URGENT Field Safety Notice

Azurion 7 M20 FlexArm system with Maquet Magnus Table
Unavailable Motorized Table and/or FlexArm Movement Potentially Resulting in Delay or Termination
of Procedure.

08-DEC-2023

Attachment 1 C&R 2023-IGT-BST-020 FSN Letter

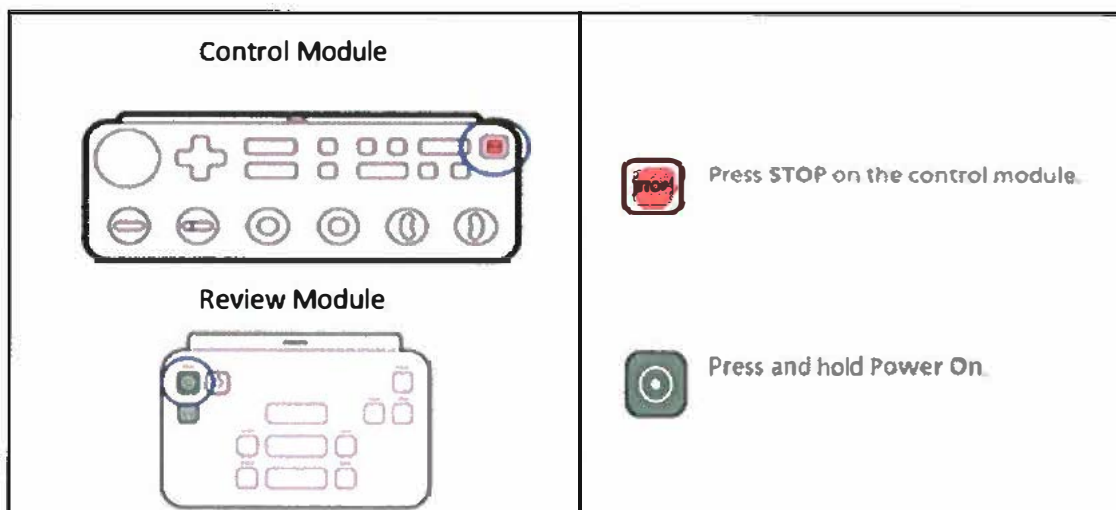
- Until Philips implements the solution in your system. during the procedure:
 - a) Avoid positioning the detector at approximately four (4) cm from the patient.
 - b) If the Connection Issue occurs, perform the following actions in **sequential order**:
 1. move the detector so that it is no longer at approximately four (4) cm from the patient.
 2. if moving the detector doesn't resolve the issue, restart the geometry of the FlexArm as follows:
 - o Press 'STOP' on the **Control Module**
 - o Press and hold the 'Power On' button on the **Review Module**

After this, both Table movement and FlexArm motorized movement will become available again.
